HOUT NEW RESIDENCE

PRRNSF20251517

HOUT NEW RESIDENCE
 921 9TH ST SW
 PUYALLUP WA 98371

A3

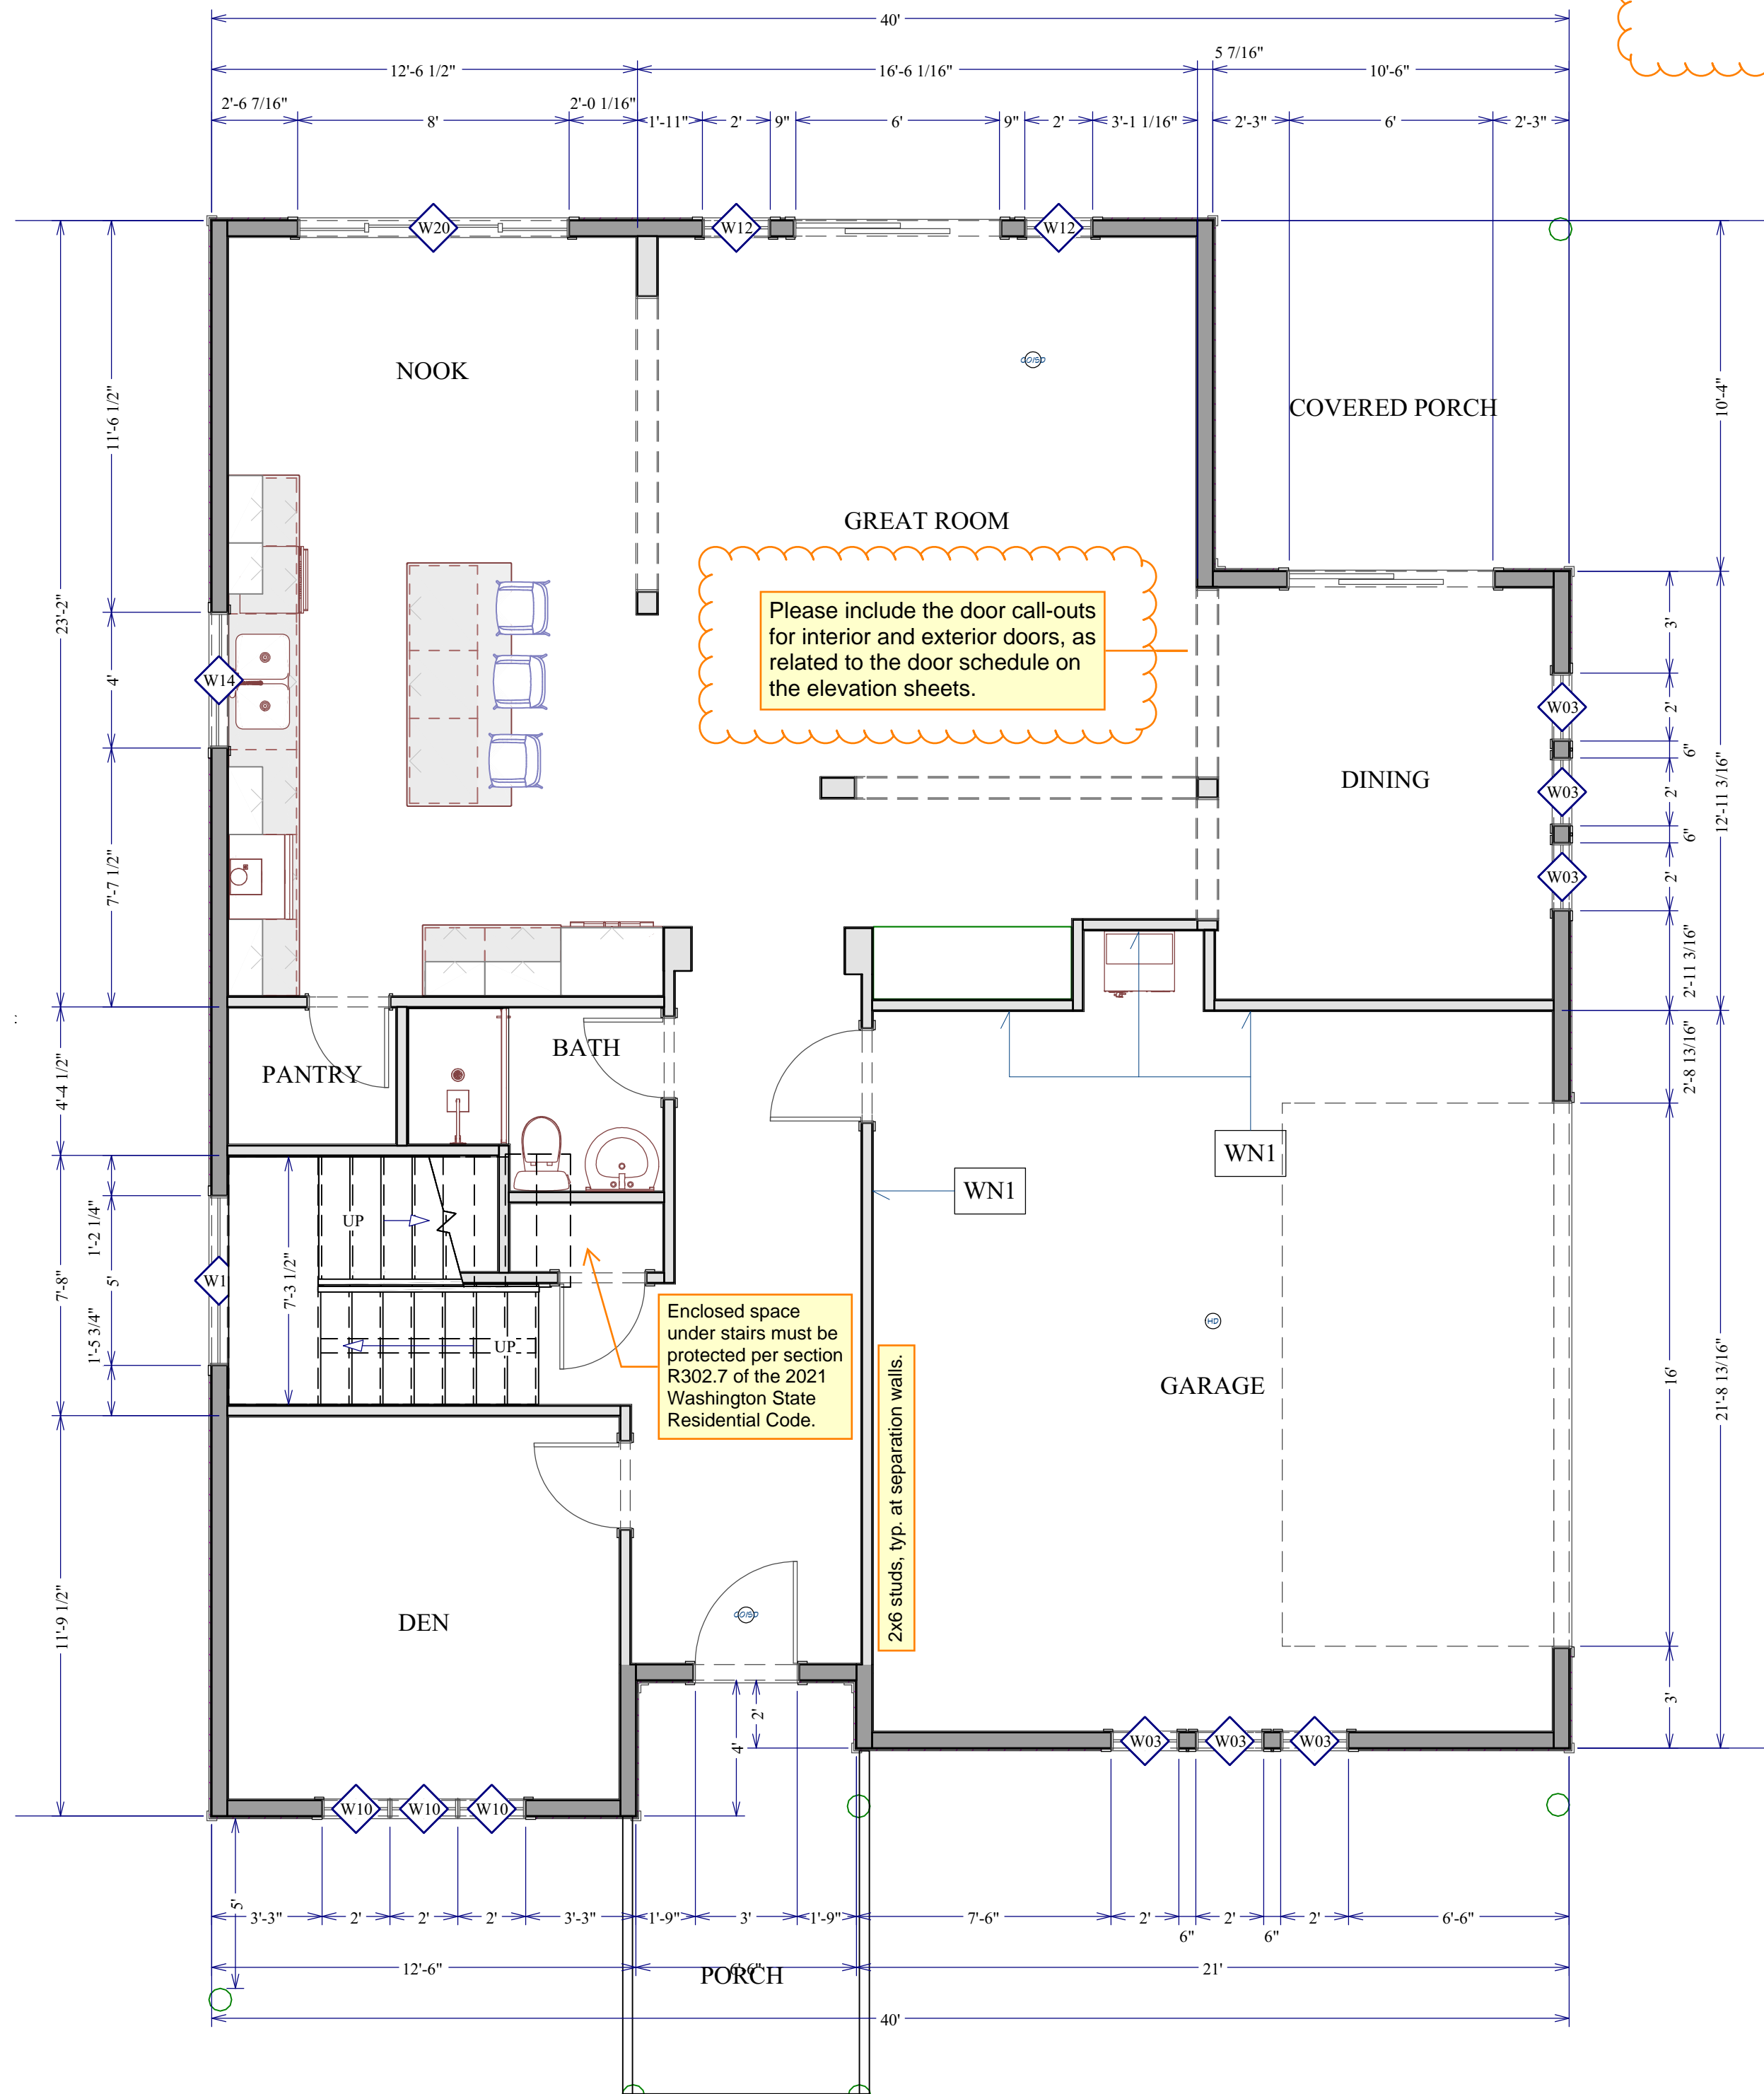
See sheet A5 for similar comments.

Please show the location of the heat pump. Plans must also include the equipment type and the minimum equipment efficiency of the heat pump in accordance with the chosen WSEC Energy Credit Option.

Please include the door call-outs for interior and exterior doors, as related to the door schedule on the elevation sheets.

Enclosed space under stairs must be protected per section R302.7 of the 2021 Washington State Residential Code.

Please show the crawl space access location and minimum size on the plans.

Please show the location of the water heater. Plans must also include the equipment type and the minimum equipment efficiency of the water heater in accordance with the chosen WSEC Energy Credit Option.

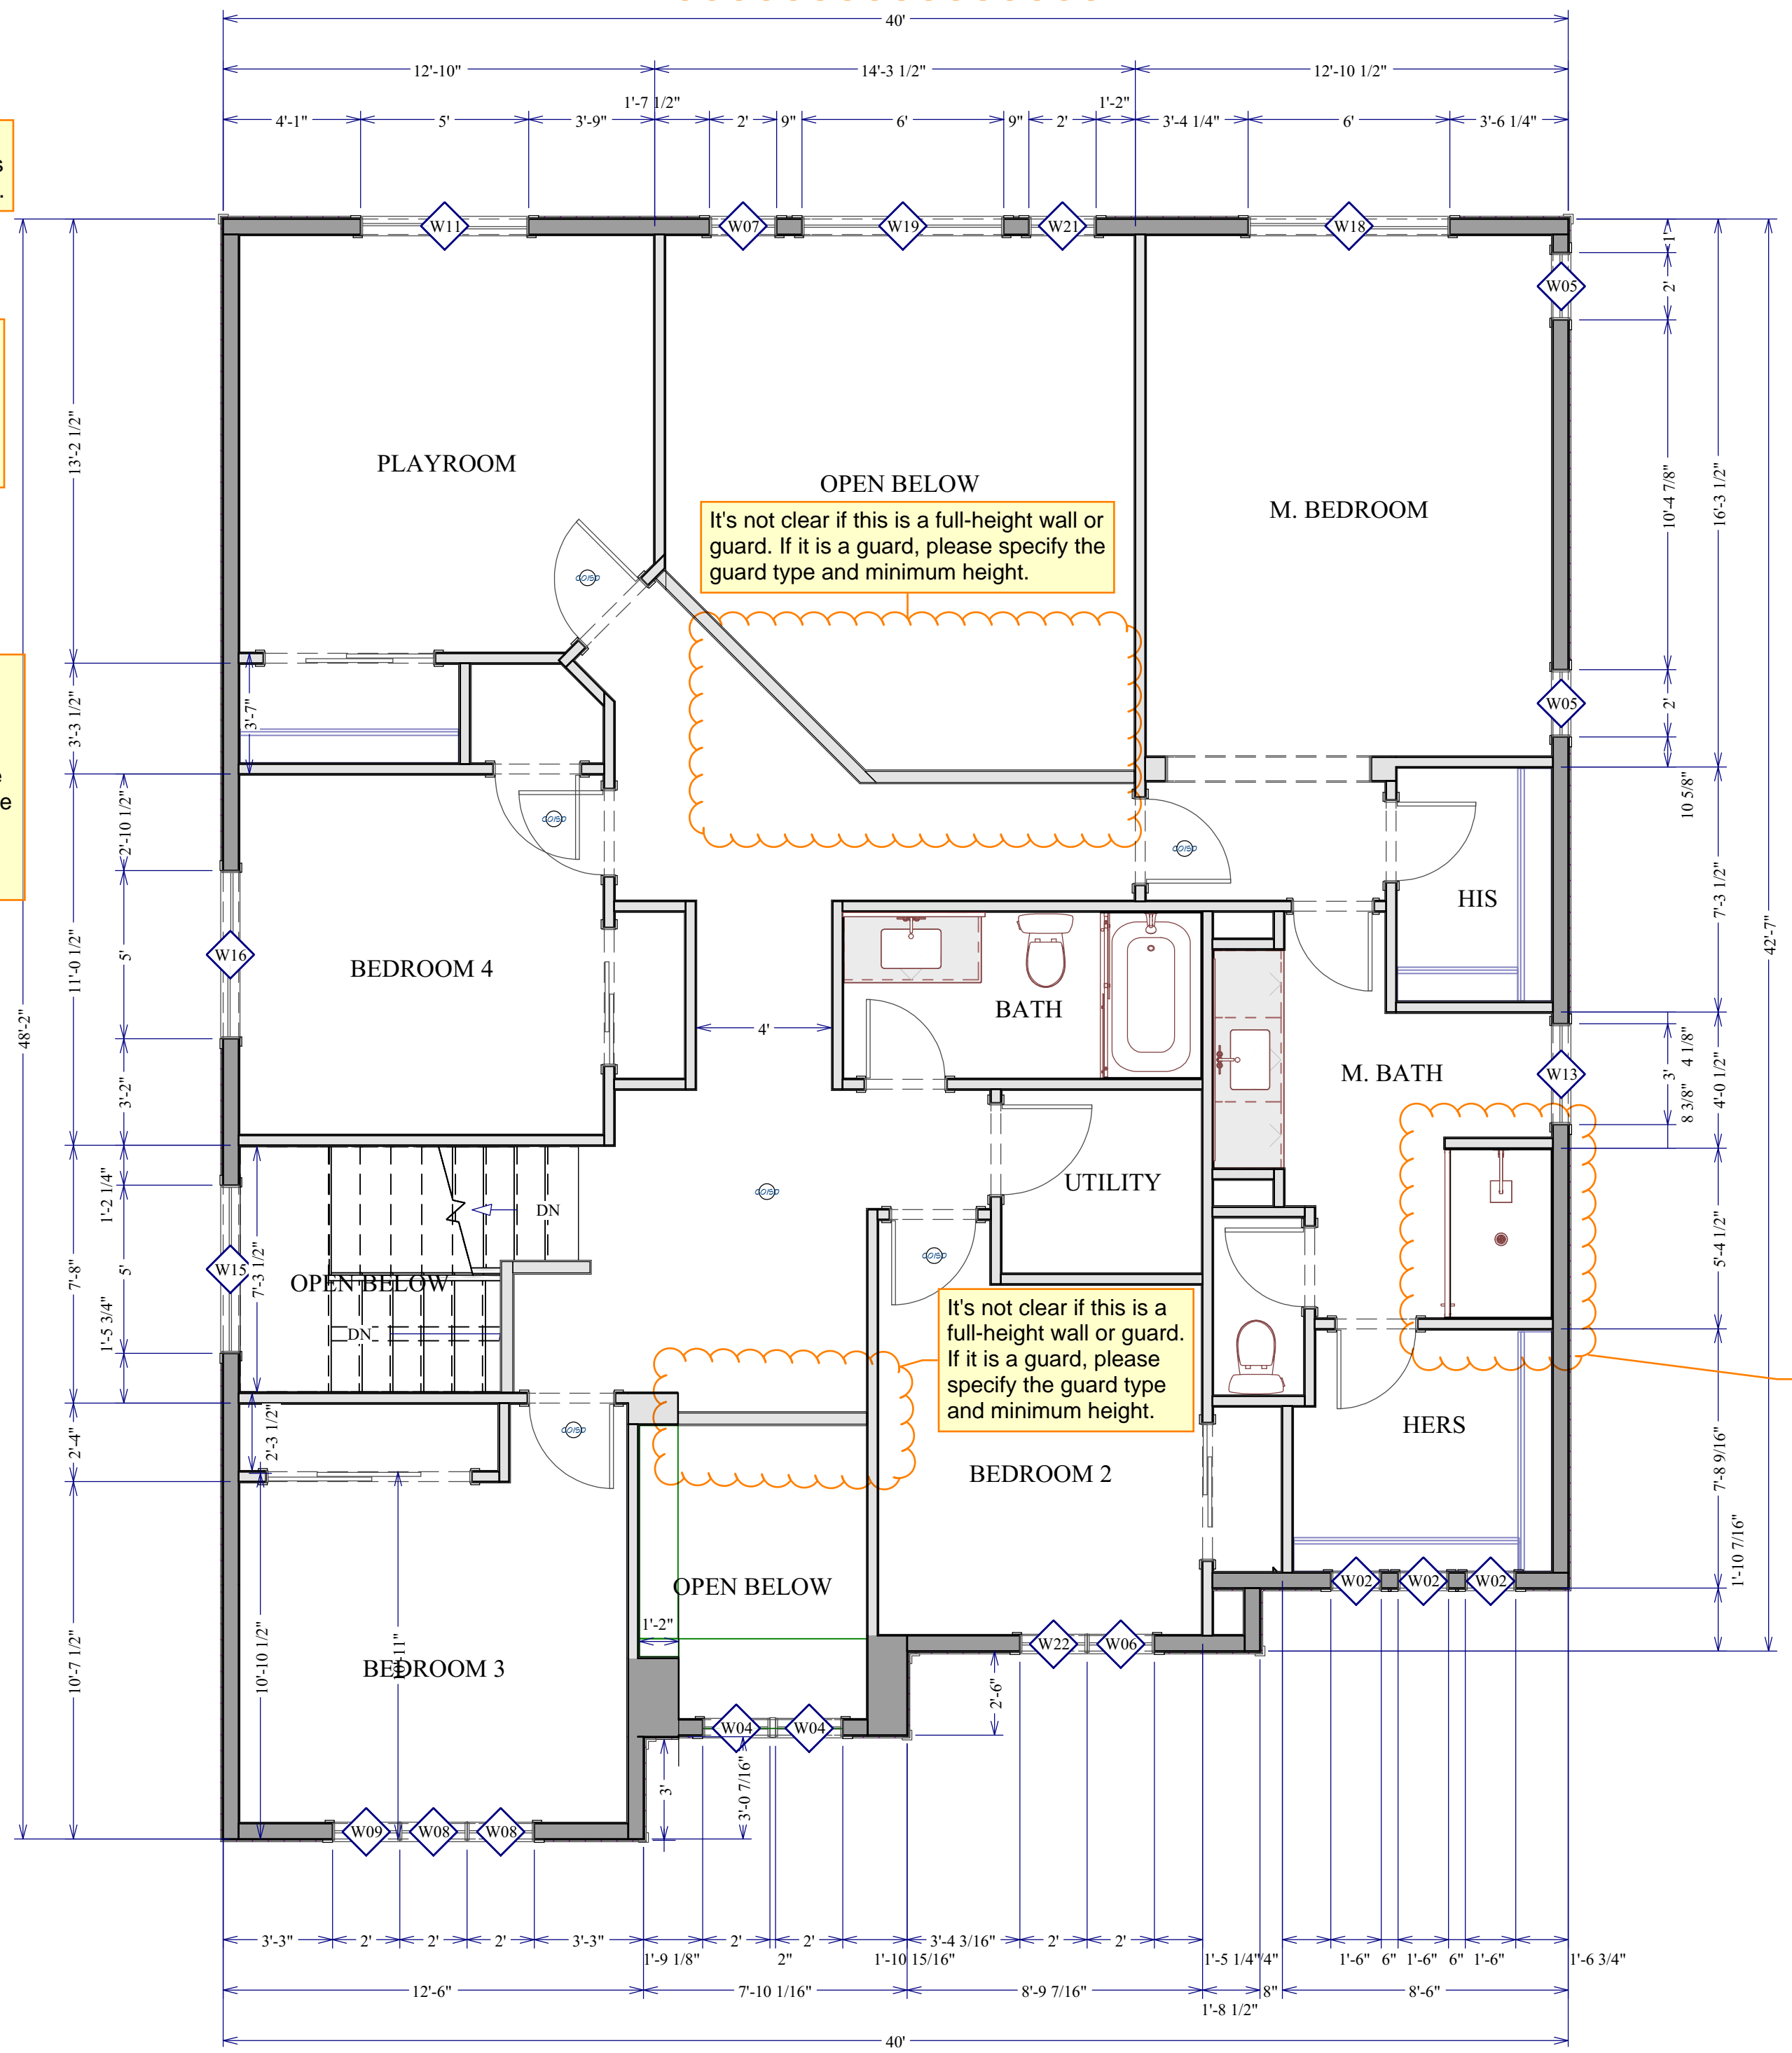
Please revise the insulation R-values to conform with 2021 Washington State Energy Code requirements.

160 CFM over electric ranges, 250 CFM over combustion ranges. See table M1505.4.4.3 in the 2021 Washington State Residential Code.

Please include the door call-outs, as related to the door schedule on the elevation sheets.

It's not clear if this is a full-height wall or guard. If it is a guard, please specify the guard type and minimum height.

Please show the attic access location and minimum size on the plans.

Confirm that a raised shower pan will be used. If the shower floor is flush with the finished floor, the floor truss layout and calculations must be revised to address the dropped floor.

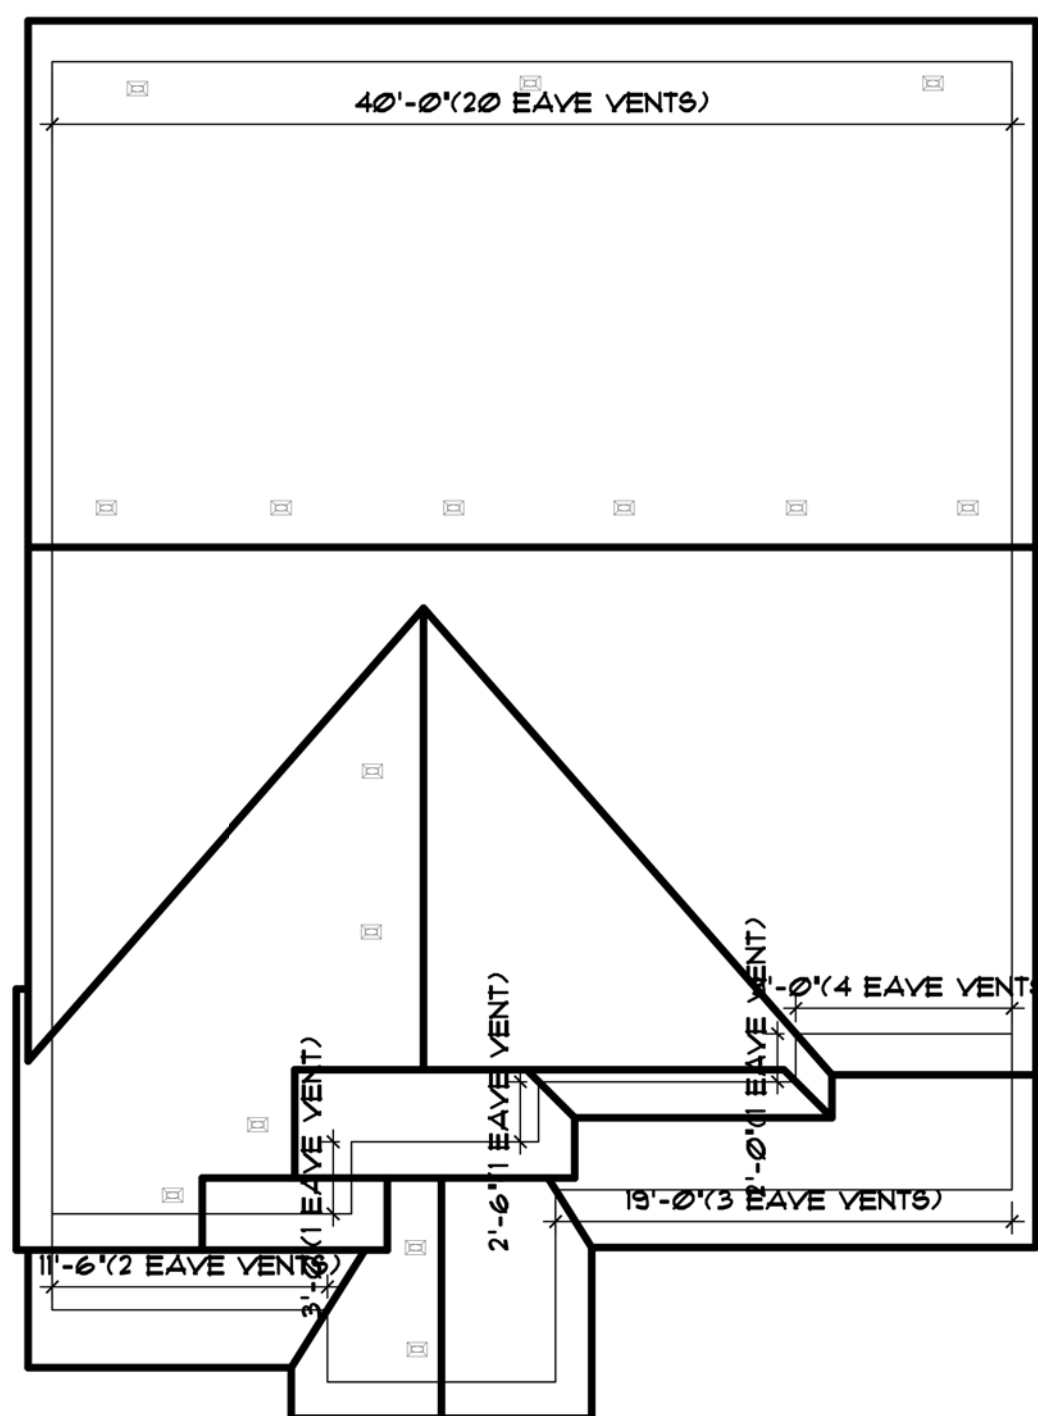
The energy credits shown here do not match the credits selected on the WSEC worksheet. Please revise the documents to match. Verify related energy items on the plans match the requirements of the selected options.

SECOND FLOOR FRAMING PLAN
1/4" = 1'-0"

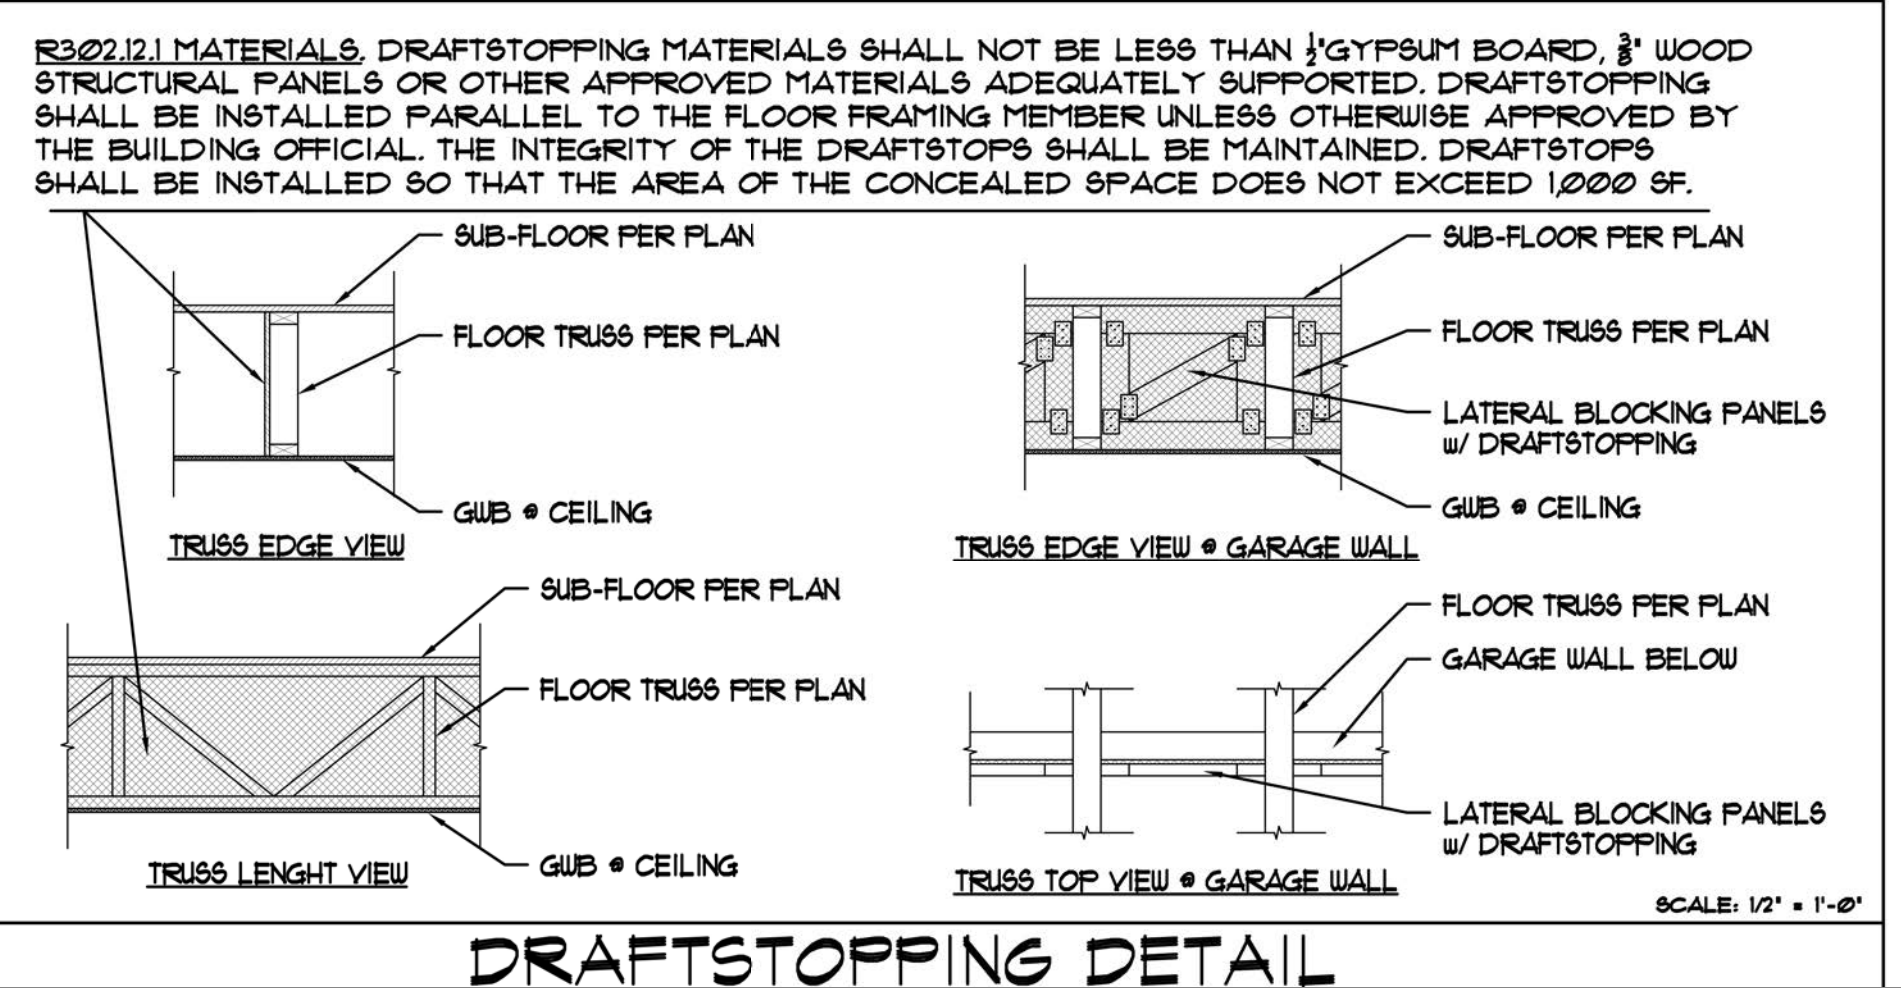
Please clarify the 6.75"x24" GLB to wall connection. The 24" deep glu-lam, flush with the top of the 18" floor trusses, will break the top plate and may also conflict with the 18" garage door header. Please consult the engineer of record. Top plates may need to be strapped across the break and a hanger may be required between the glu-lam beam and header if the header runs directly underneath (or near) the top plates.
